Groundwater & Wastewater Services
Well Project File & Data Review Worksheet

GWS File #: 18160 WASPS App #: 2392

PERMIT TO CONDUCT MAJOR REPAIR AND/OR ABANDON A WATER SUPPLY WELL

Rept. for ARGU Review
5820 Dixie Rd., Charlotte, NC
PID# 141-271-06
File # 18160
Application#2392

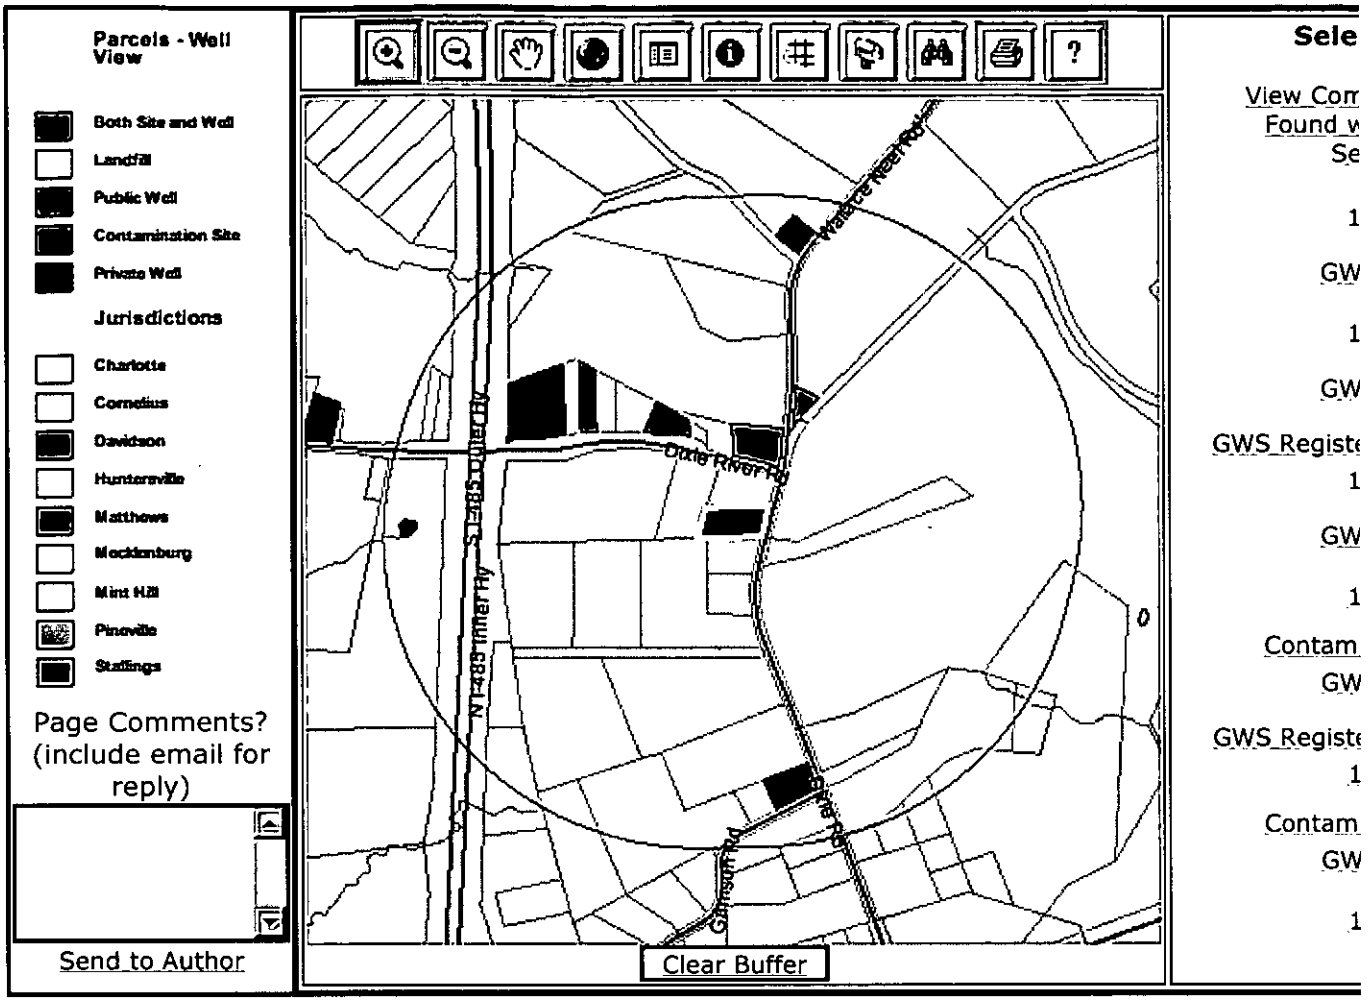
06/12/07 (Tues.) - Received request for ARGU review for private well abandonment for a WSW located at 5820 Dixie Rd., Charlotte, PID#141-271-06. According to the WIS, there is an existing well at this property.

06/12/07 (Tues.) –Conducted ARGU Review. Identified 2 MPL sites within 2,000' of the subject parcel.

MPL# 981 Handy Pantry #29
5806 Wallace Neel Rd., Charlotte, NC
PID# 113-154-10
NCDENR UST Section Inc. #23013
Source-petroleum USTs

NCDENR database indicates that this is a High risk GW incident.

MPL investigation completed in 2003. Fourteen WSWs located and 2 were sampled for VOCs with no wells impacted.

The subject site is within 500' of this MPL site.

MPL# 941 Ford, James H. Property
5729 Wallace Neel Rd., Charlotte, NC
PID# 115-191-07
NCDENR UST Inc. # ?
Source-reportedly orphan petroleum UST

NCDENR PIRF BTEX in onsite WSW and MW. Site reportedly old store which sold gas and kerosene.

MPL investigation completed in 2000. Ten WSWs located and no wells were sampled related to this MPL.

The subject site is within 1,000' of this MPL site.

Based on review of our files, the permit for a private well abandonment at PID# 141-271-06, 5820 Dixie Rd., Charlotte, NC is approved. Well sampling reported MPL and NCDENR files indicated no detections, so the well requires abandonment under the Mecklenburg Co. Groundwater Regulations dated Oct. 5, 2004, Chapter II Construction, Repair and Abandonment for Private Water Supply Wells with no special conditions.
